INSIDE EDGE
PROPERTIES

1209 Michael Street North

Urban Design Review Panel

December 5th, 2025

LEVEL 8-30 FLOOR PLAN (TOWER TYPICAL)

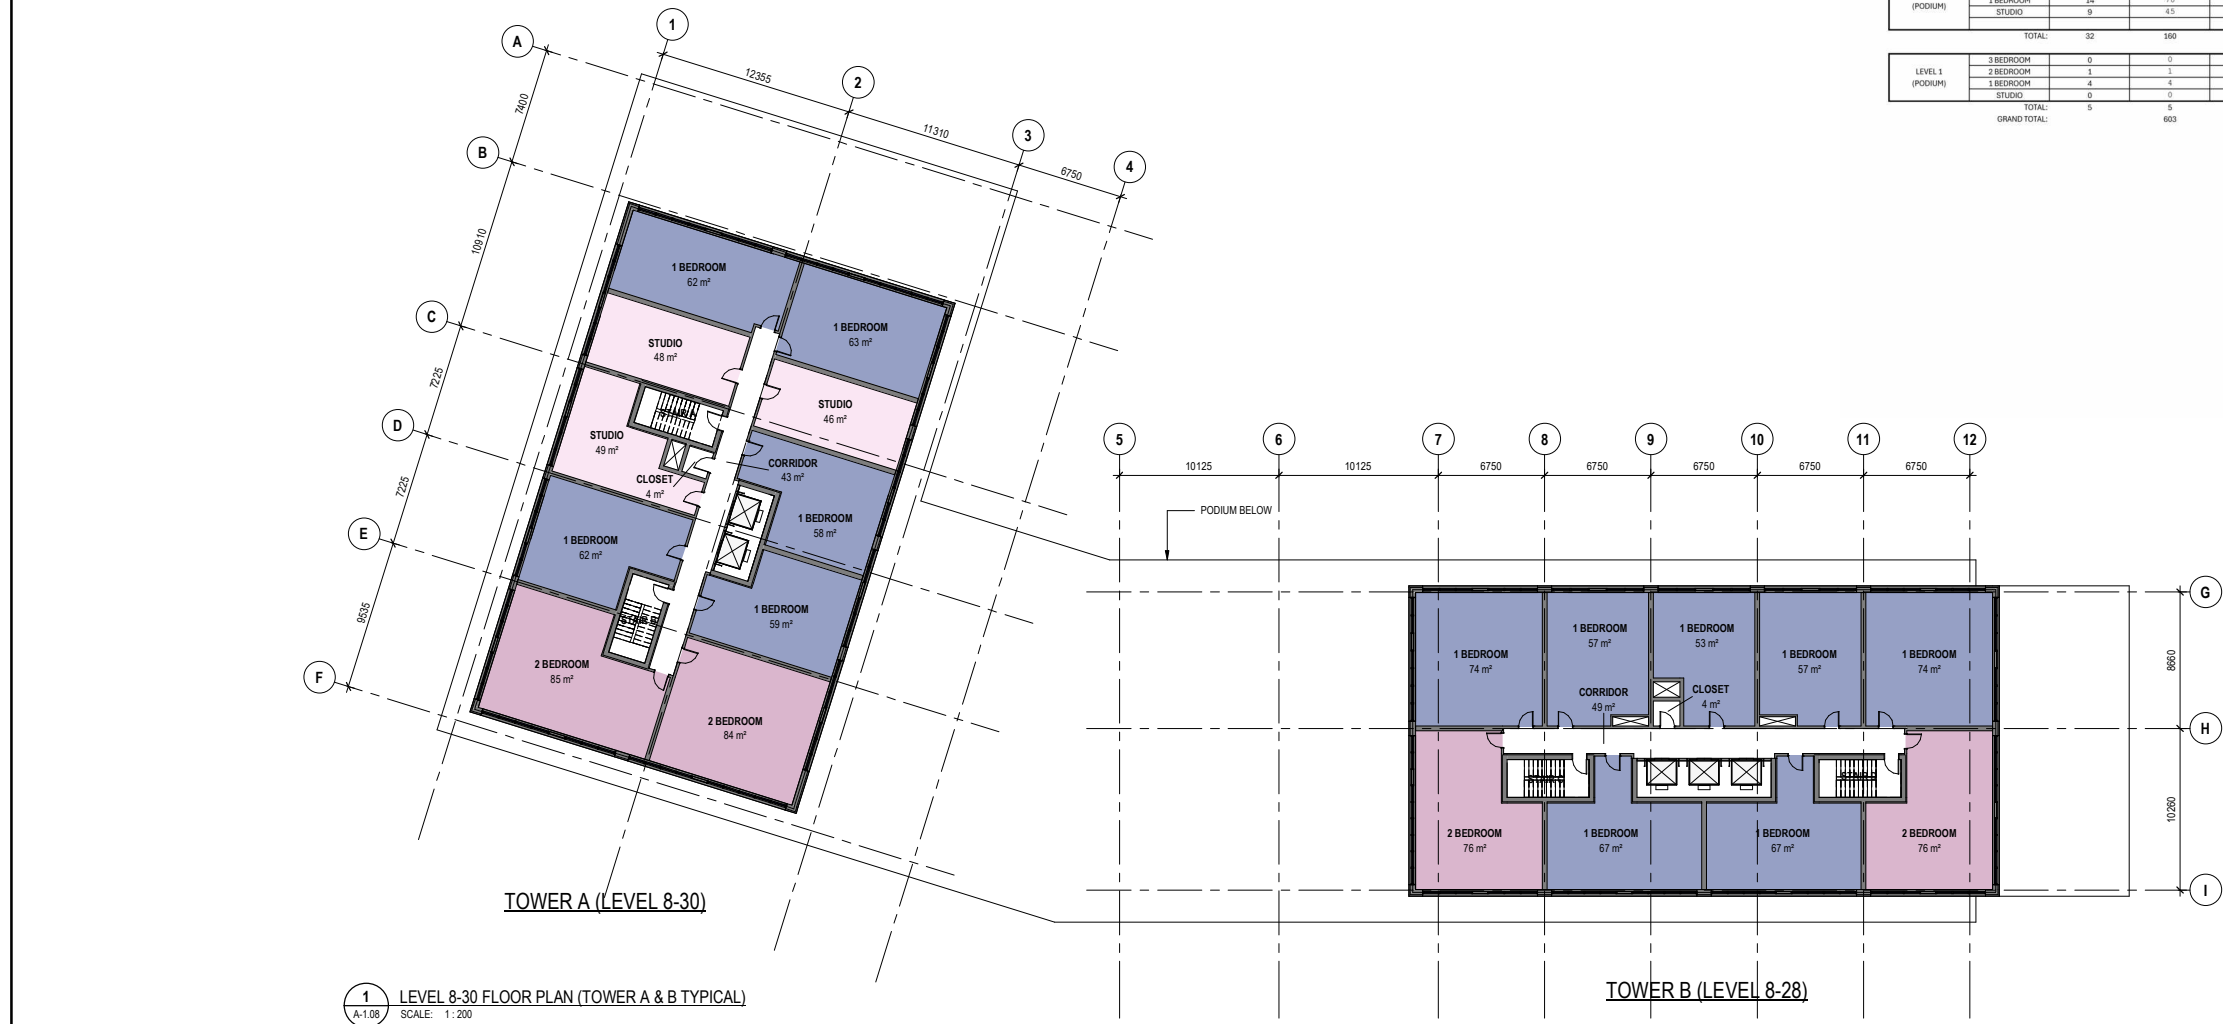
12. The 750m2 tower floor plans and tower separation distances are appreciated.

The current tower floor plate configuration shows areas of 736.15 m2 (tower A) and 738.76 m2 (tower B). (setback from the podium have pushed the building back and slimmed the floorplate further).

15. Provide a podium with a tower setback.

- / Plans have been revised to have a 1.5 m setback of the tower from the podium

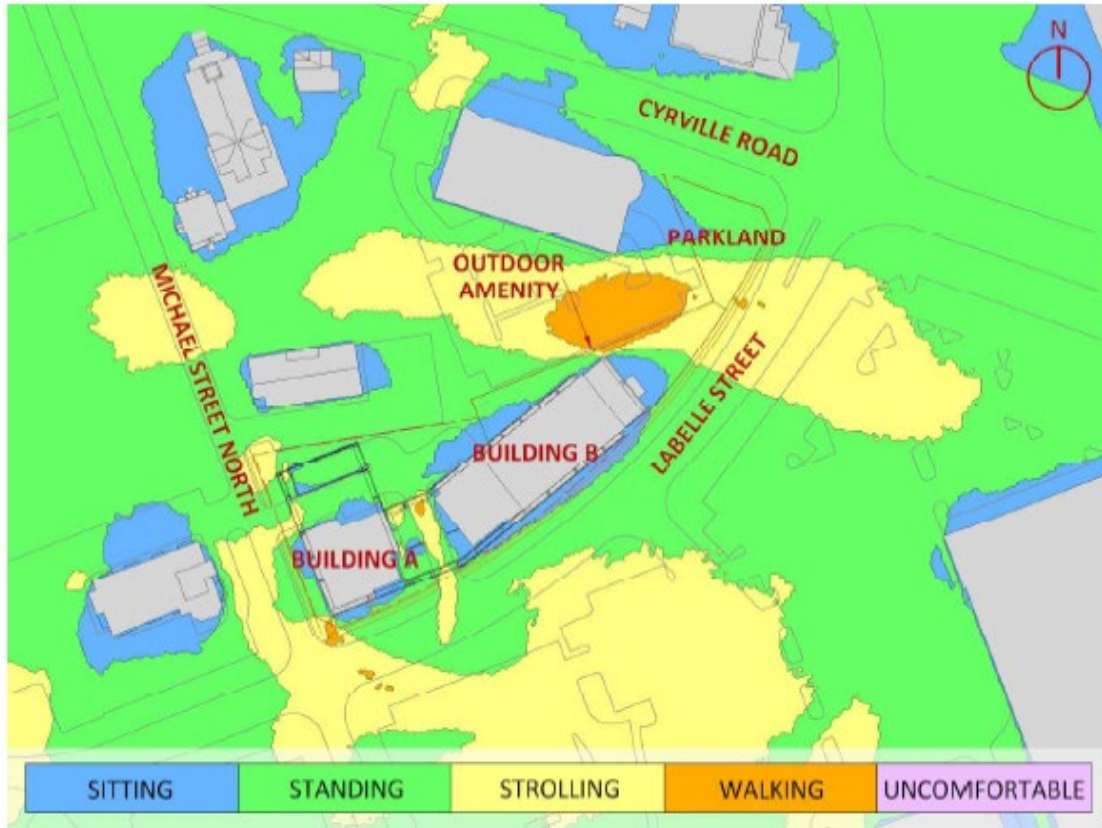
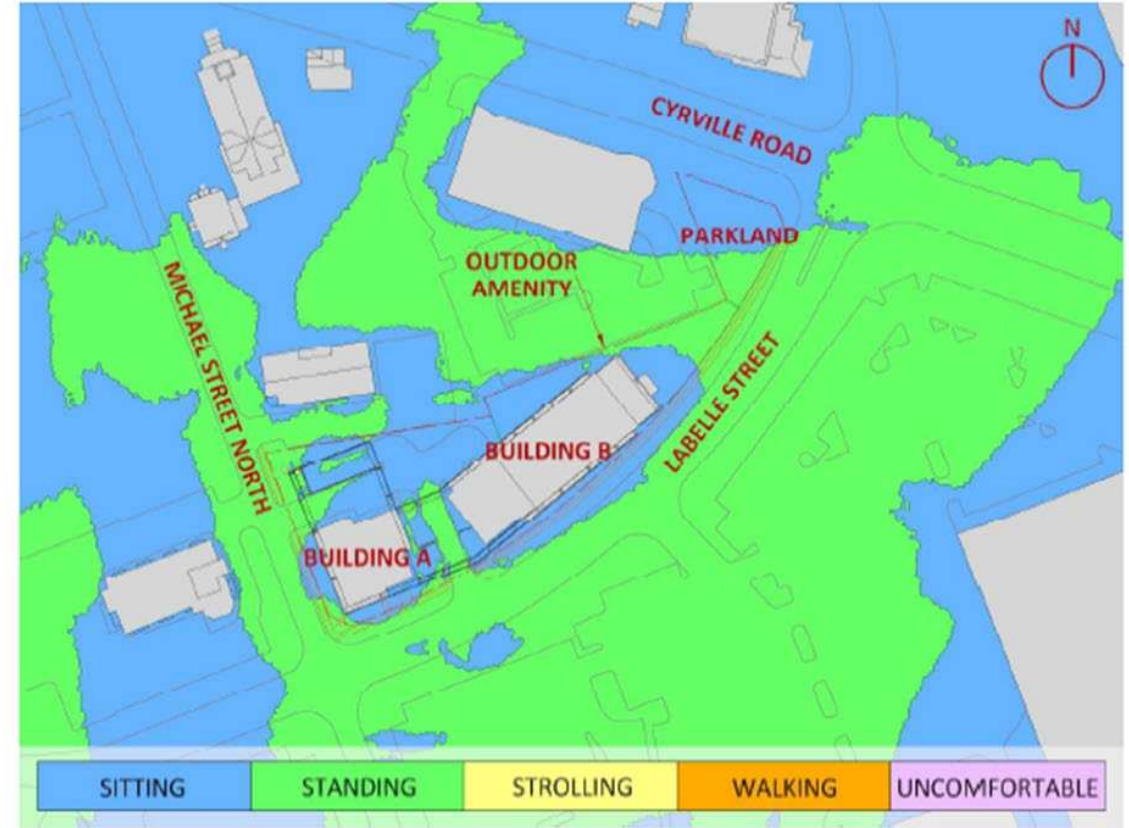
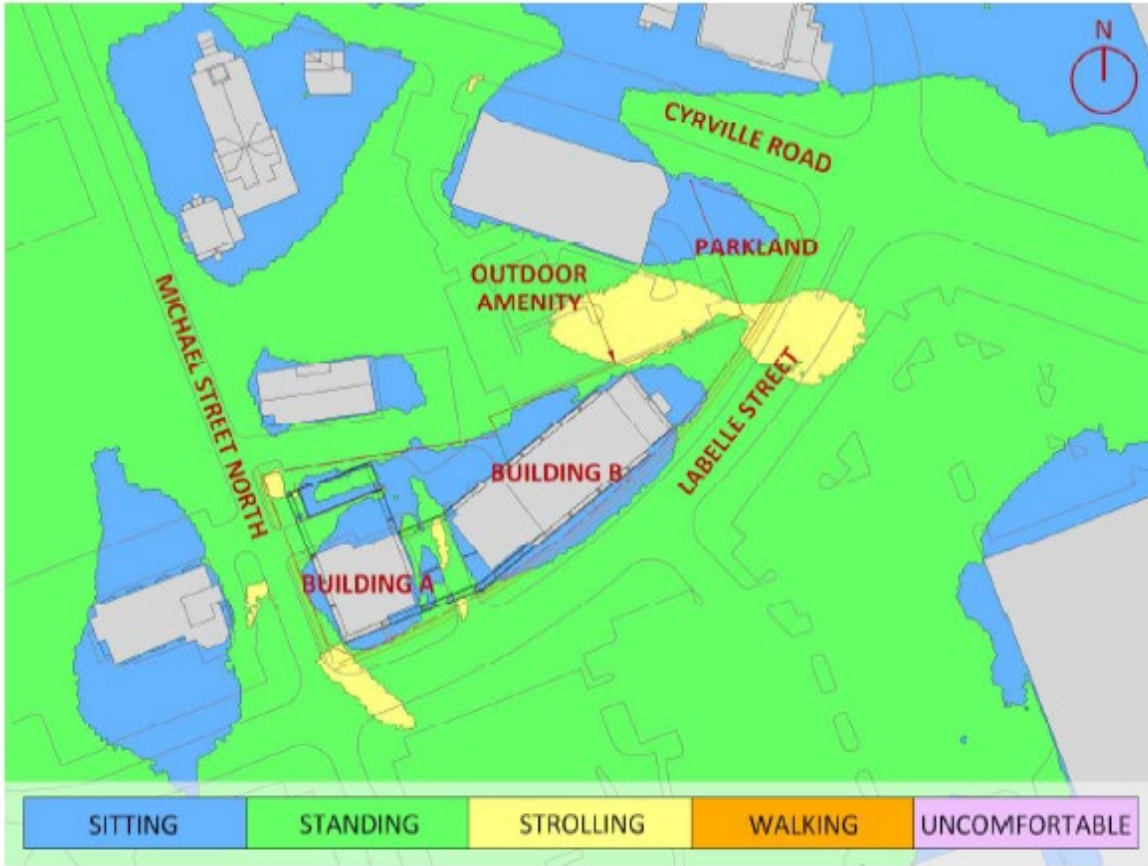
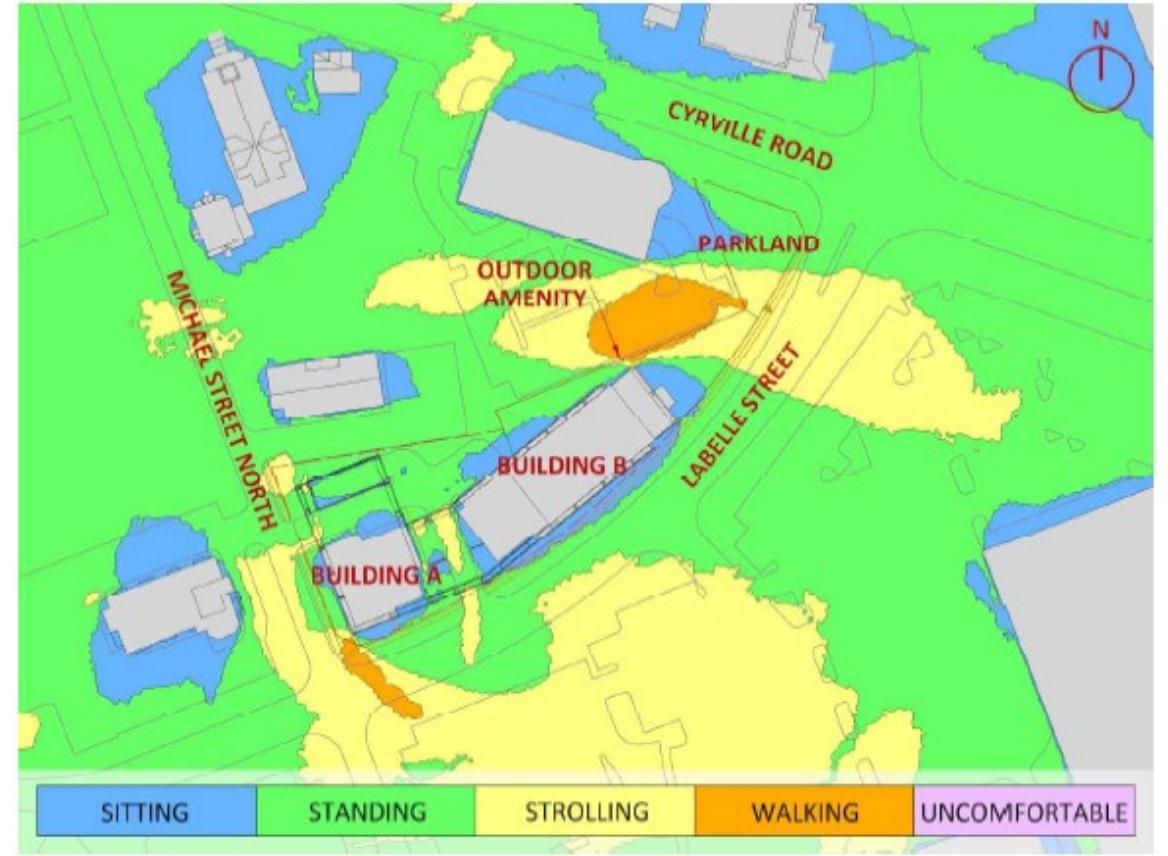
13. From an urban design perspective, height increase should be rationalized based on microclimate impacts to the surrounding area. A variation in building heights should be provided between the two towers.

- / The towers currently stand at 28 and 30 stories, with a 6-storey podium. A wind study has been carried out and provided.
